McLaren Senna – Rear Wing End Plate Rework

Bulletin type:	Service Campaign Bulletin
Reference number:	SCB 15 A 001
Campaign reference:	04R
Attention:	Retailer Service Managers and Retailer Technicians
Affected vehicles:	McLaren Senna
Situation:	Potential for insufficient tightening torque of the screw fixings for the Rear Wing End Plates
Procedure:	To be actioned during the vehicle's next Retailer visit. Please refer to the information outlined in this document to ensure correct fitment and tightening torque is applied to both Rear Wing End Plates
Date:	25 th July 2019

1 Layout overview of Rear Wing End plate and fixing screws (4)

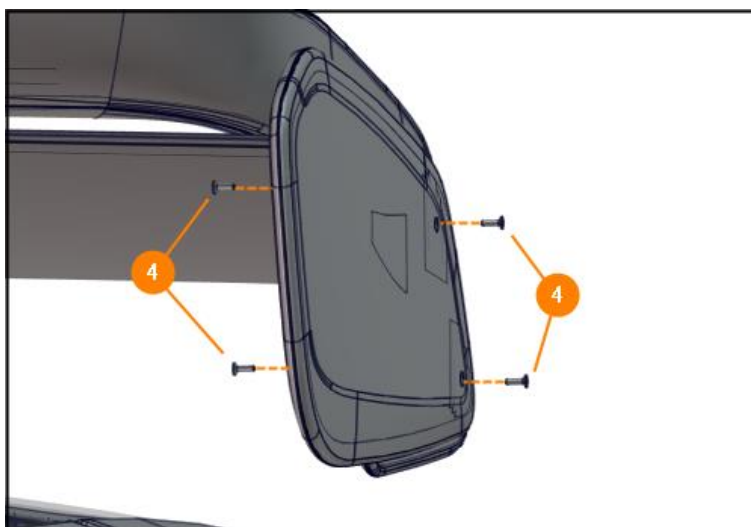
McLaren Automotive has identified through our continuous product quality monitoring, that a number of McLaren Senna vehicles may have an insufficient tightening torque of the screw fixings on both of the Rear Wing End Plates. This could result in the fixing screws and end plate(s) to become loose on its mounting point.

To carry out the required re-work, addition of thread locker (equivalent to Loctite 272 specification) to all of the fixing screws (on both sides) is required, as well as ensuring both Rear Wing End Plates are correctly positioned, and the fixings screws are tightened to the specified torque of 1.5Nm.
